# Access Compliance Report

## Public Rights-of-Way

Intersection ID: 3040	Main Street: FOX_GLEN_RD	Cross Street: RED_TAIL_CT	Location: SW
ADA ID: CBCD448B7C54	Ramp Type: Directional1	Initial Pass/Fail: Fail	Overall Compliance: No
Severity Score: 22.5			
Codes/Mitigation Info/Possible Solution		Field Measurements/Component Compliance

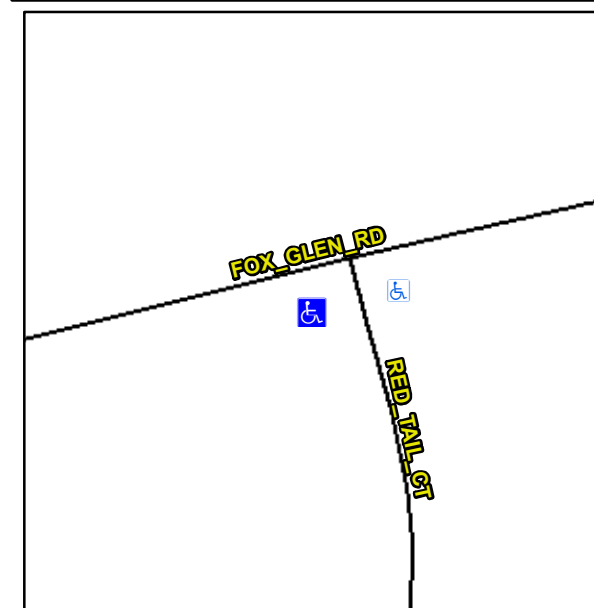
**R304.5.1, R304.2.2, R304.5.3**

Compliance	Description	Data	Compliance	Description	Data
N/A	Ramp Length (in)	120.0	N/A	Grade Break?	N/A
No	Ramp Width (in)	47.0	N/A	Grade Break Slope (%)	0.0
No	Ramp Slope (%)	11.5	N/A	Grade Break XSlope (%)	0.0
No	Ramp XSlope (%)	2.8			
N/A	Flare Type LT	N/A	N/A	Flare Type RT	N/A
N/A	Flare Slope LT (%)	N/A	N/A	Flare Slope RT (%)	0.0
N/A	Flare Traversable LT?	N/A	N/A	Flare Traversable RT?	N/A
N/A	Landing Length (in)	0.0	N/A	DWS Provided?	N/A
N/A	Landing Width (in)	0.0	N/A	DWS Contrast?	N/A
N/A	Landing Slope (%)	0.0	N/A	DWS Length (in)	N/A
N/A	Landing X Slope (%)	0.0	N/A	DWS Full Width?	N/A
N/A	Landing Curb? (Y/N)	N/A	N/A	DWS Offset LT (in)	N/A
N/A	Shared Landing?	N/A	N/A	DWS Offset RT (in)	N/A
N/A	Gutter Ponding?	0.0	N/A	Gutter Slope (%)	N/A
N/A	Gutter Lip Ht (in)	0.0	N/A	Gutter X Slope (%)	N/A
N/A	Painted X Walk1?	No		Road Slope (%)	0.5
	X Walk 1 Direction	To NE		Road X Slope (%)	2.1
	X Walk 1 Width (in)	N/A		Clear Space?	N/A

**Remove & Replace Entire Ramp.**
